Chemical & Nuclear Engineering

Subject: Docket No. 50-252, Facility License R-102
**Request for Additional Information Regarding the AGN-201M Reactor
Application for License Renewal (TAC No. ME1590).**

Response to Request for Additional Information
From The University of New Mexico
AGN-201M Reactor
Docket 50-252

Figure 19 – Radiation Levels Associated with 4 Watt Operation

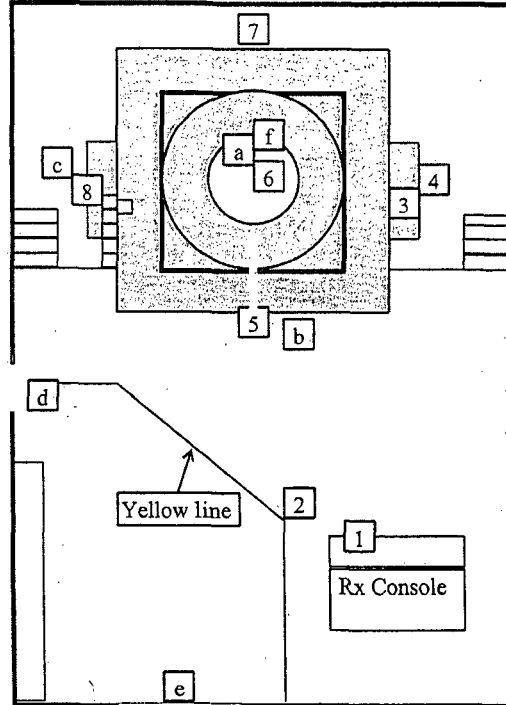
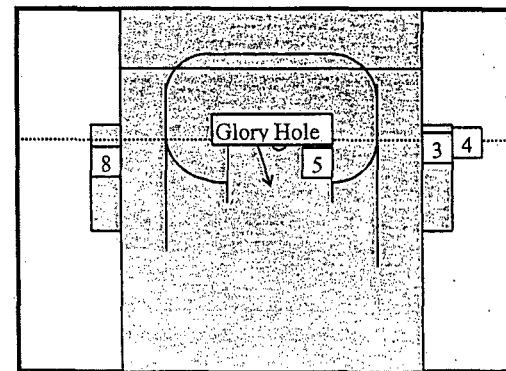
4. *The third paragraph of Section V.B refers to figure 19; there is no reference to figure 18 and figure 19 seems to be missing.*

Figure numbering was incorrect. The figures are now numbered as follows:

Figure 19 was missing and has now been added as shown on next page. The paragraph has been revised to read:

The radiation levels associated with 4-watt operation (peak thermal flux of 2.0×10^8 n/cm² -sec) are given in Figure 19 as measured on February 12, 2009. (The radiation values scale linearly with power.)
